From: Mike Miller
Sent: Friday, January 11, 2019 5:13 PM
To: Glen Southerland; Wendy Farley-Campbell
Subject: FW: Cannery Station

Subject: Cannery Station PUD, Response to Sandow Engineering Technical Memorandum dated November 2, 2018 and Issues Discussed in January 16, 2019 Meeting between Applicant and City Representatives.

CITY FILE: RESOLUTION PC 18 34 SUB 01
MAP & TAX LOT: 18-12-14-20-00700
OWNER/APPLICANT: Cannery Station Development, LLC
AGENT: TBG Architects & Planners
PROPOSAL: **TENTATIVE SUBDIVISION OF CANNERY STATION PHASE 1: 6-LOT COMMERCIAL SUBDIVISION TO BE LOCATED AT THE SOUTHEAST CORNER OF US 101 AND MUNSEL LAKE ROAD**

Detention Worksheet

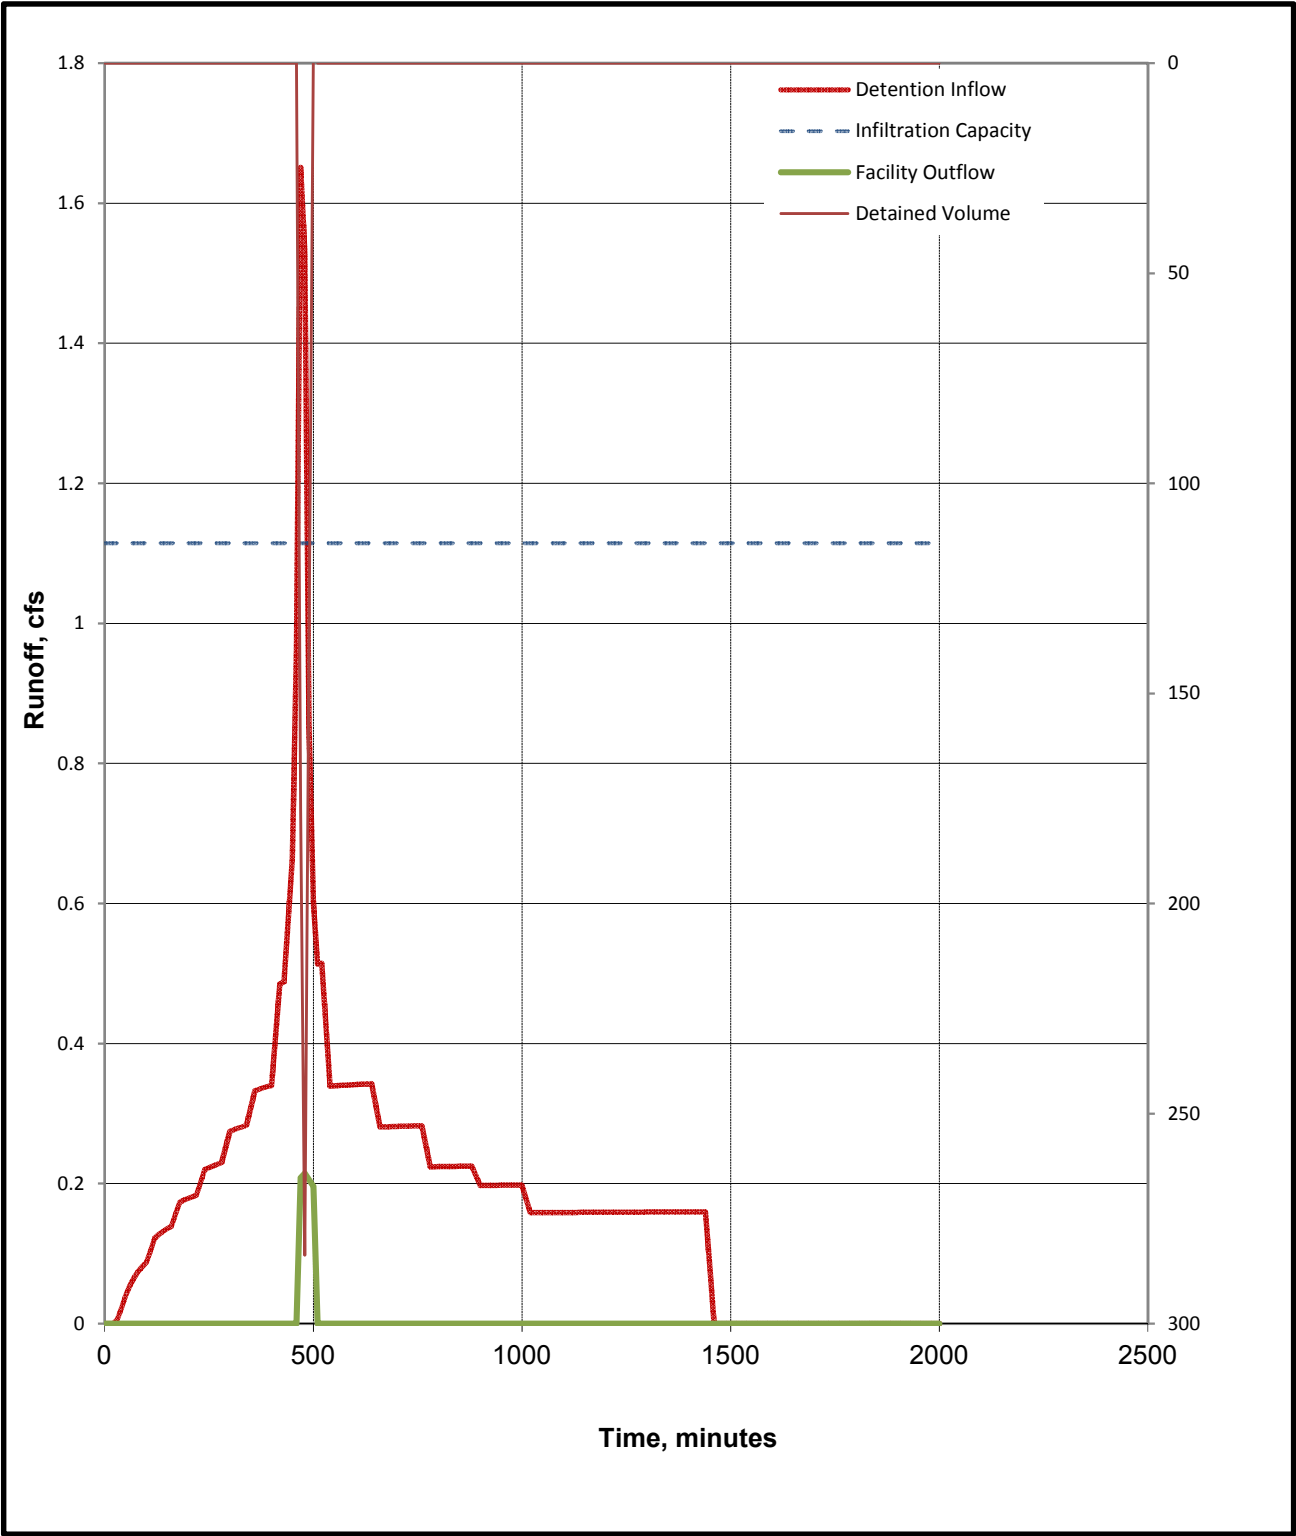
2. The Pre vs Post Development runoff table should show pre and post development runoff (after detention) for each basin. The table, as it is, shows post development W/Detention of 0.24 cfs during the 25 year storm, but I can't find in the calculations which basin that is coming out of. My guess is that it's from A11, but the Detention Worksheet for A8, A9, A11 (page 24 of the pdf) show a 25 year runoff of 0.00 cfs. You are correct, the detention worksheet that was attached was an older worksheet. I'm not sure how I managed to send the wrong one. We updated the worksheet, but neglected to send it to you. I have attached the updated worksheet that shows a max post-development release rate for Lot 2 of 0.24 cfs.

Figure 1: Right Turn Area on Munsel Lake Road at Highway 101.

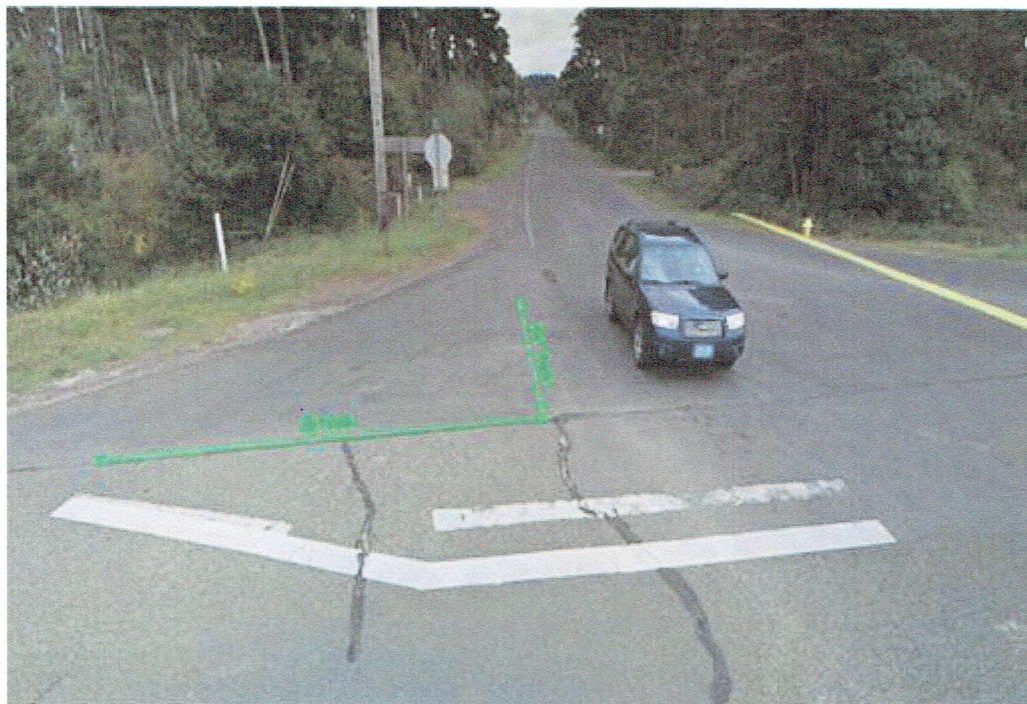
While the asphalt is not specifically striped for a right-turn pocket, there is indeed sufficient pavement width for a vehicle making a right turn to be in a separate space from the vehicles making a left turn. As you can see in Figure 1 below, there is sufficient area for a separate space for a right turn movement. During the traffic count, vehicles were observed frequently utilizing this space for a right turn movement. The traffic models were calibrated to existing conditions including the use of that space for a right turn pocket. ODOT has conditioned the project to install a separate right turn pocket when the Munsel Lake Road frontage is improved.

The location indicated as a turn lane, will conflict with the legal unmarked crosswalk as defined in ORS 801.220 (1) (a) “The connection of the lateral lines of the sidewalks ... on opposite sides of the streets.”

Prior to final approval of Phase 2 of the Development the applicant shall construct or enter into an agreement with the City to construct, a right-turn lane for westbound-to-northbound right turns. The turn-lane shall meet ODOT standards (Lane County uses ODOT Standards as well) for tapers and storage length. The applicant shall also dedicate sufficient width to provide a minimum 35 feet right-of-way on the southerly side of the Munsel Lake Road centerline for the length of the site property. This dedication shall meet the requirements of Lane County as described in separate correspondence dated January 14, 2019 from Brad Lemhouse. In addition, the dedication shall include sufficient right-of-way at the southeast corner of Munsel Lake Road maintain curb return radii required intersection setbacks.
